## MEMORANDUM – ADDENDUM NO. 1

**To:** Interested Vendors  
**From:** Cindy Clack  
**Date:** 12/15/2025  
**Re:** RFB2026-10 Covered Bridge Road Water Main Extension -- Addendum No 1

**PROJECT TITLE: Covered Bridge Road Water Main Extension, RFB2026-10**

09

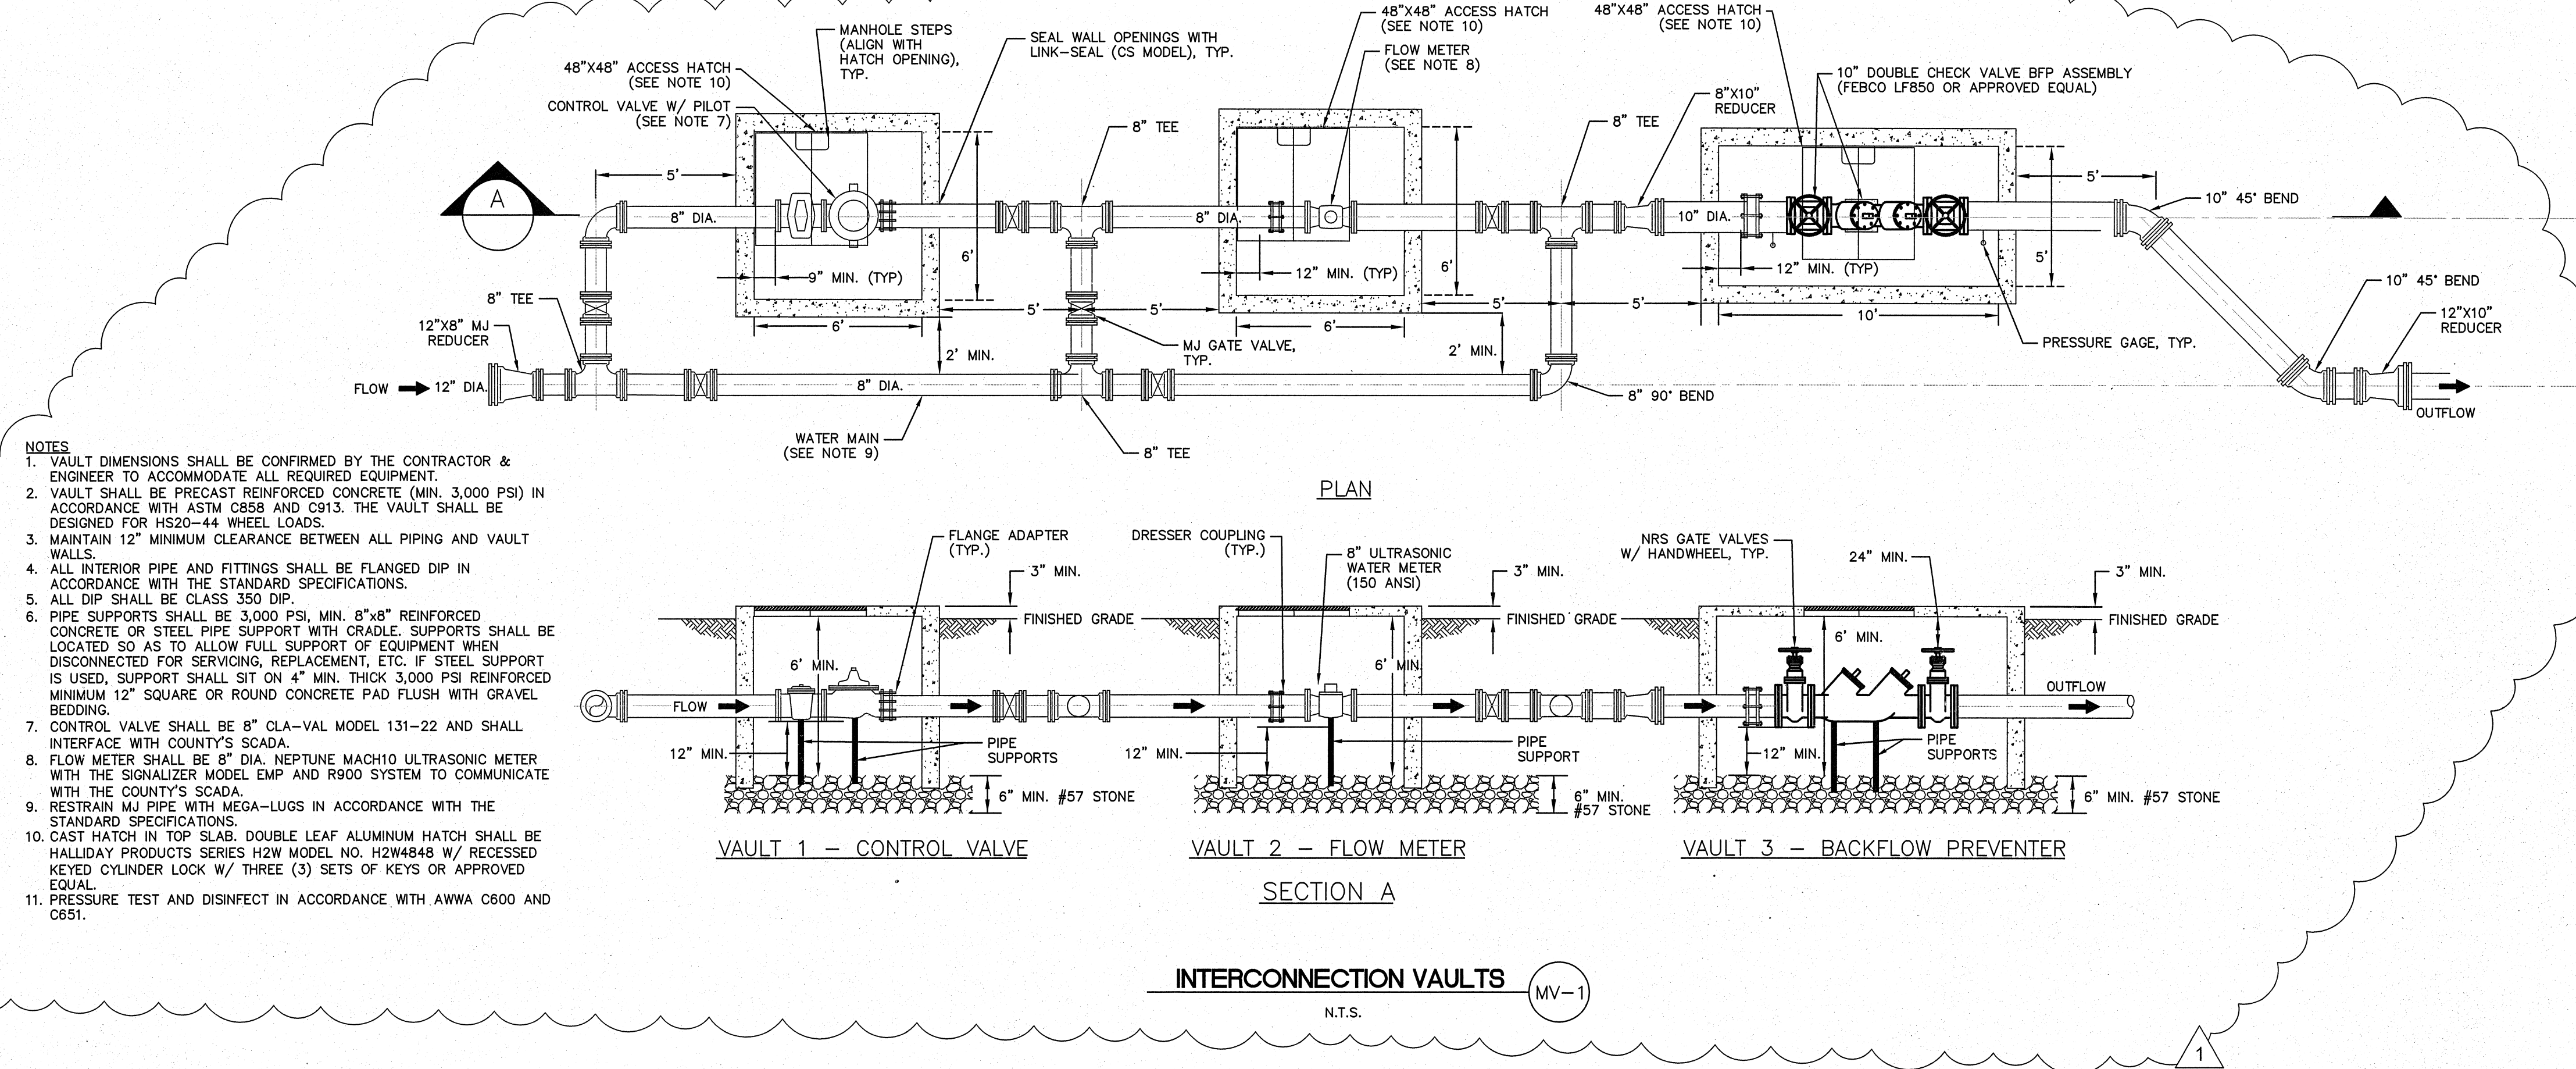
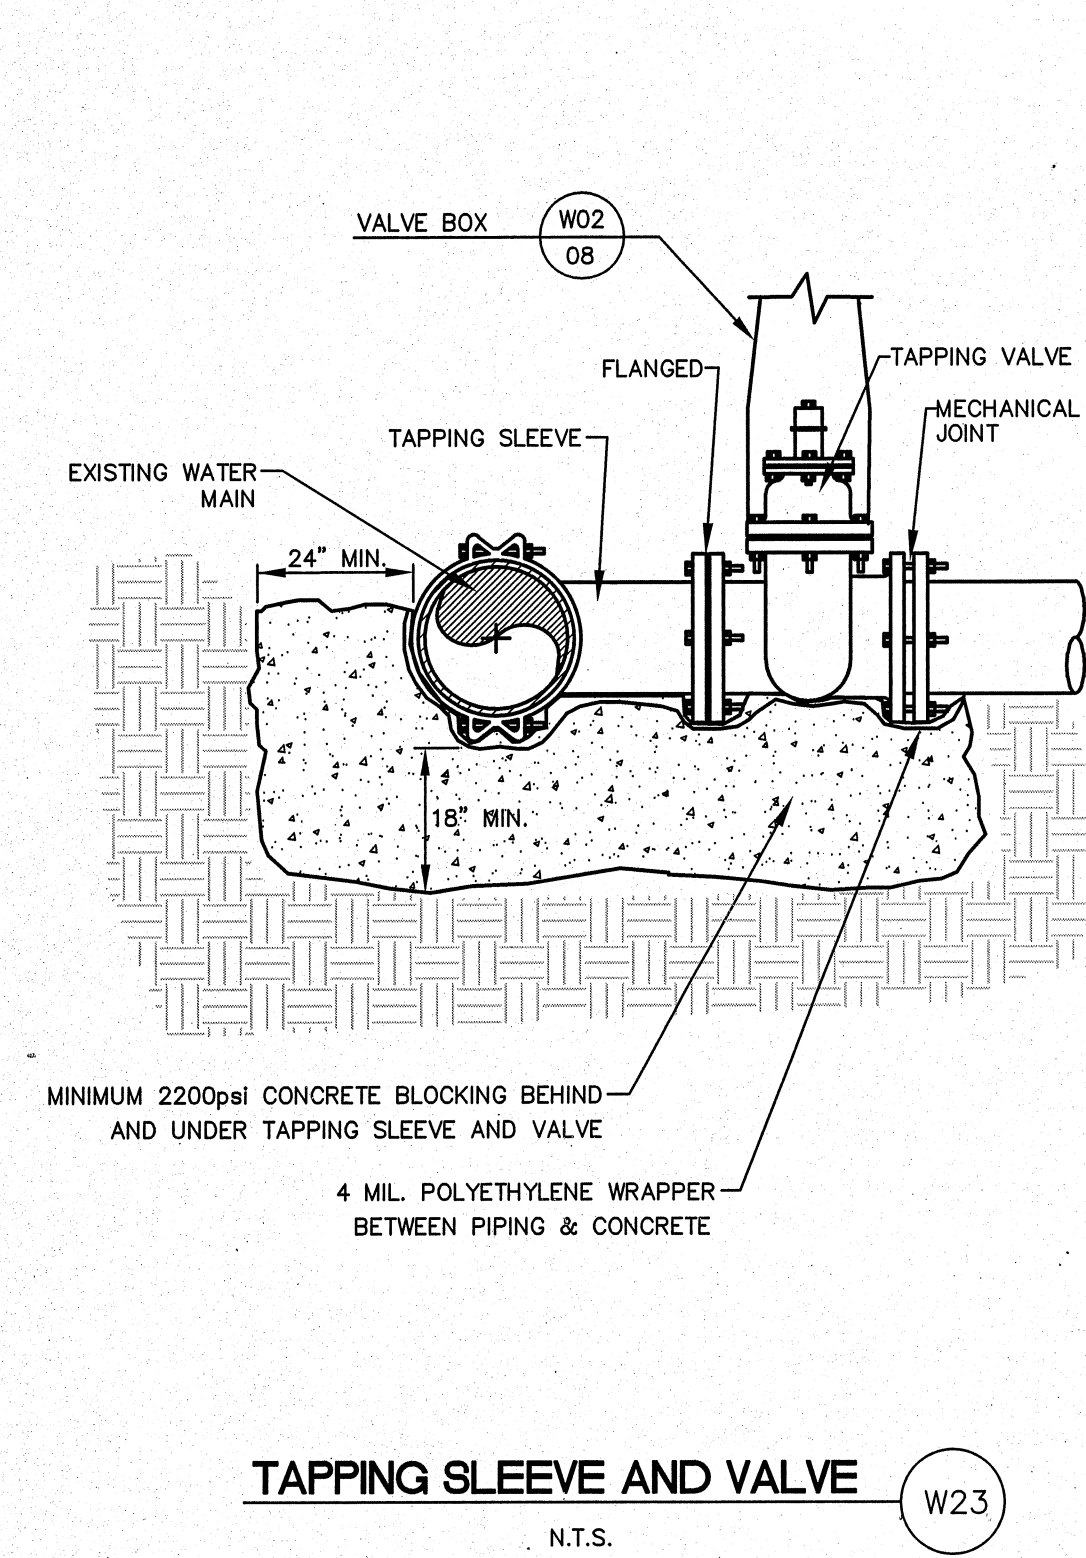
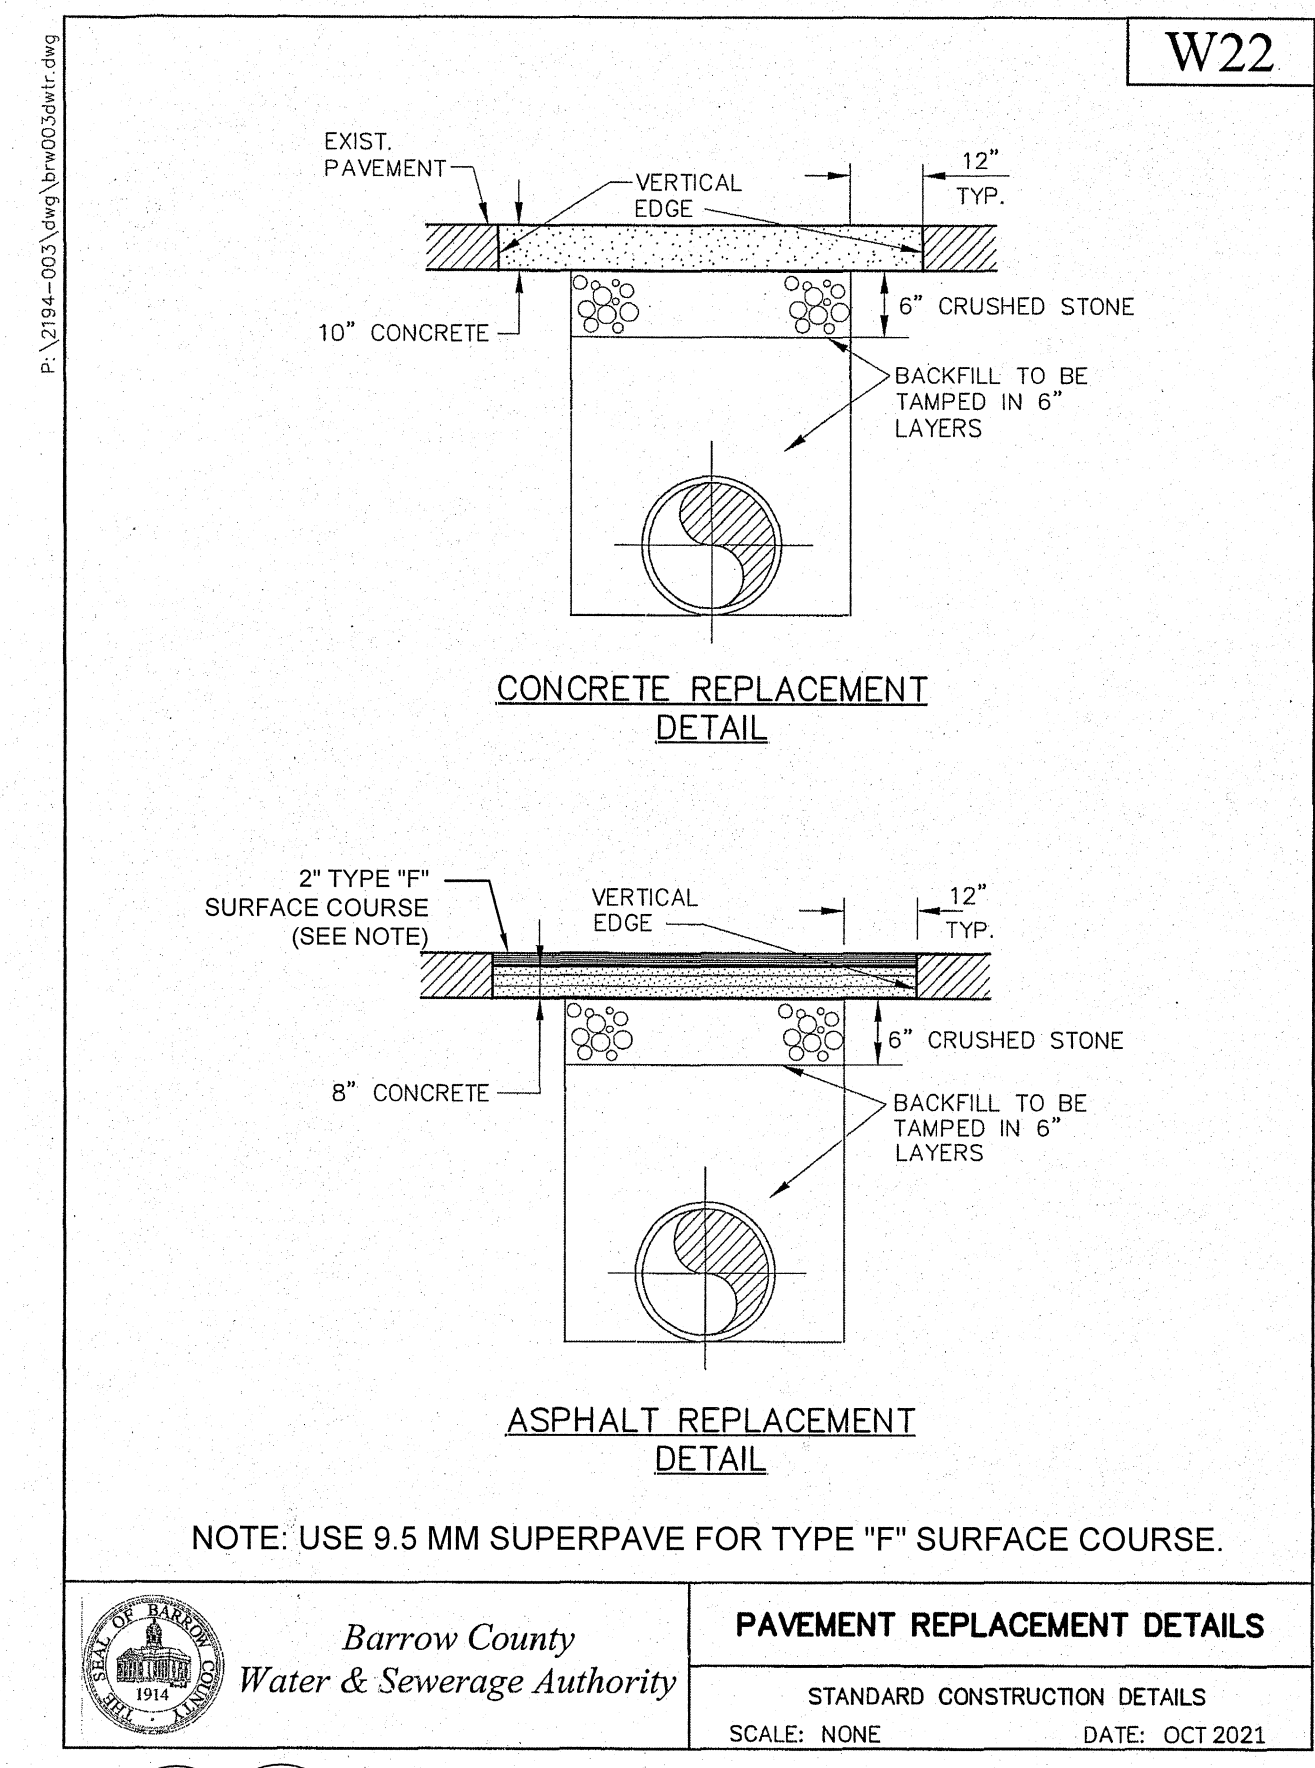
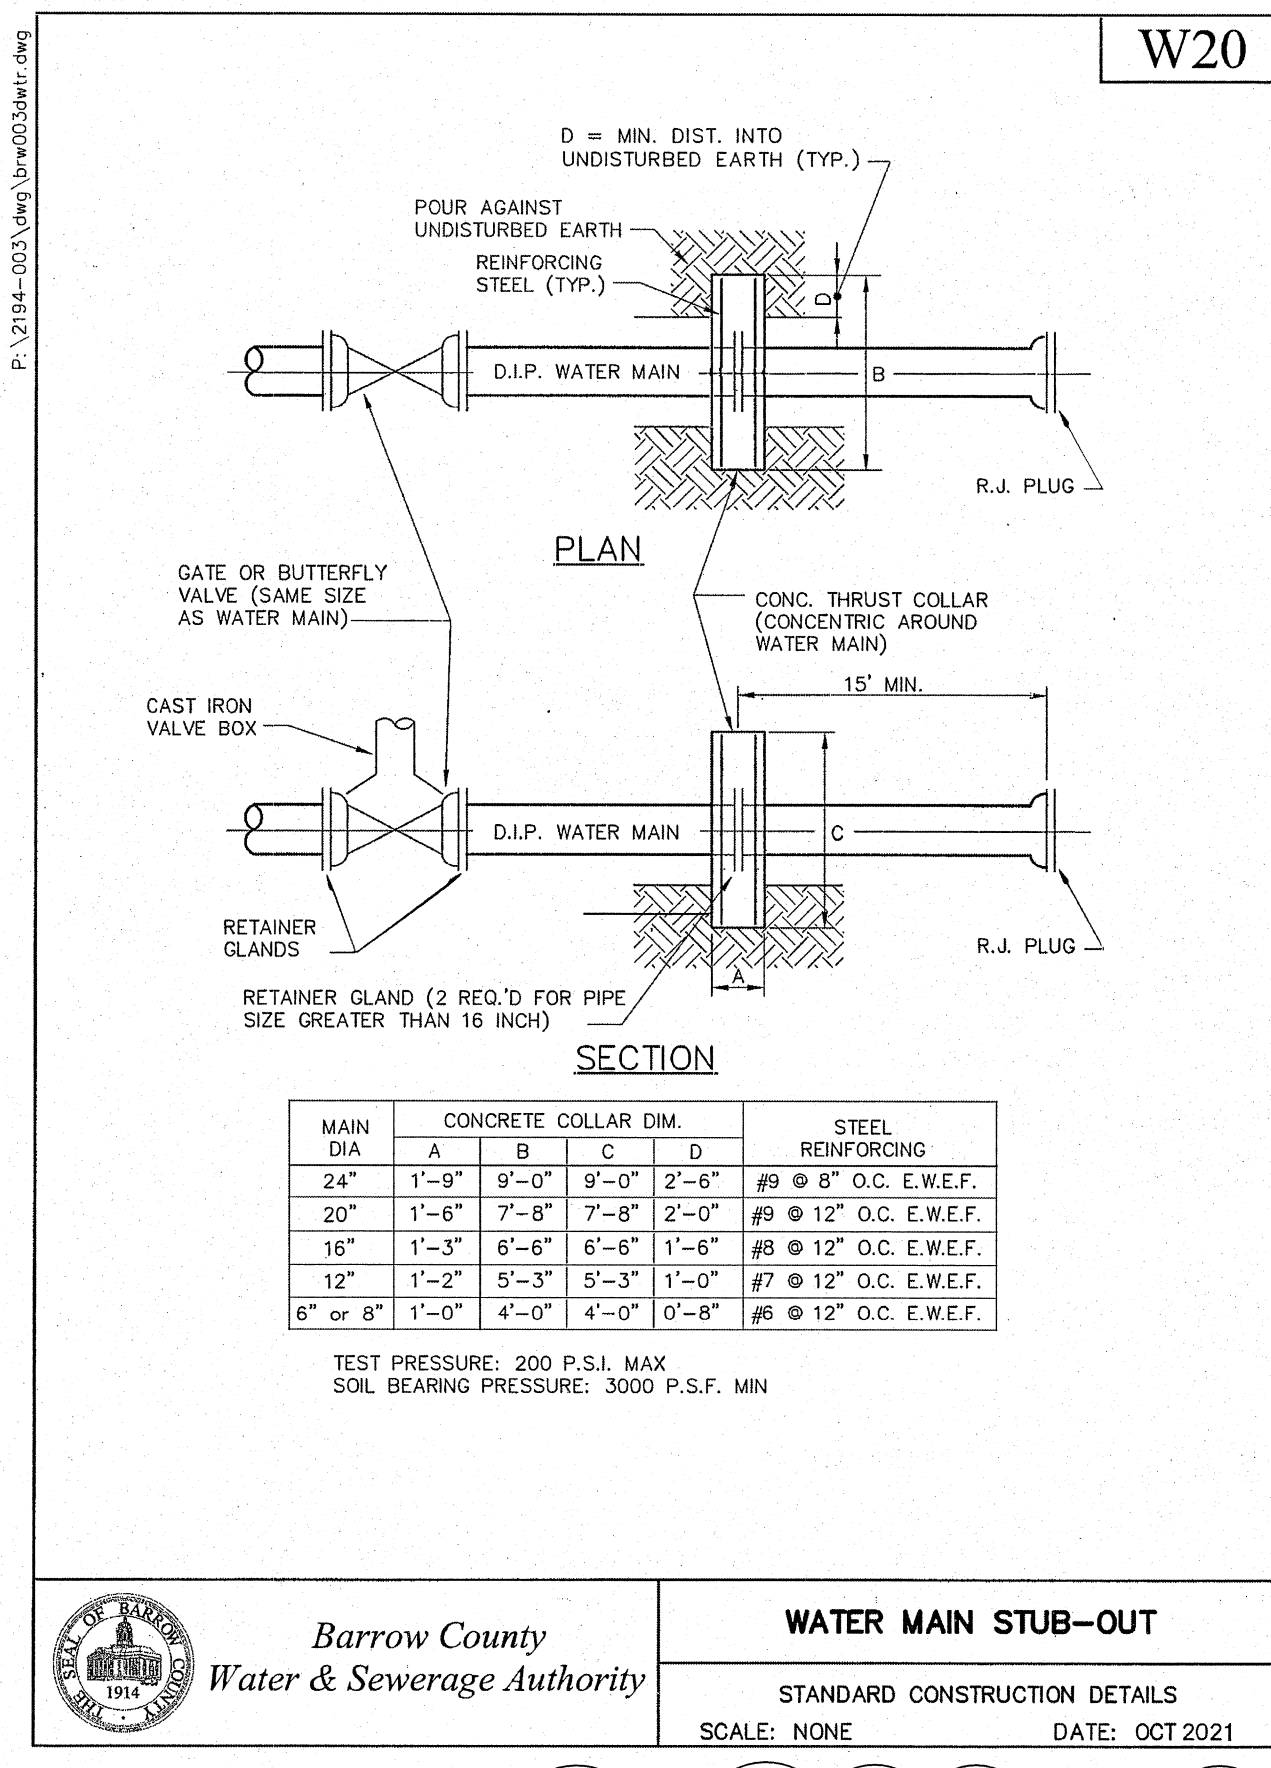
- A1. After consideration, no allowance will be added. These items will remain under the Interconnection Water Vaults pay item.
- Q2. *Can you please confirm vault size and location of transducer in backflow vault.***

- A2. See updated Sheet 9, Detail MV-1 for vault dimensions. Correct callout on Sheet 6 for 6'x6' control valve vault. See updated electrical plan set, Sheet E-3.
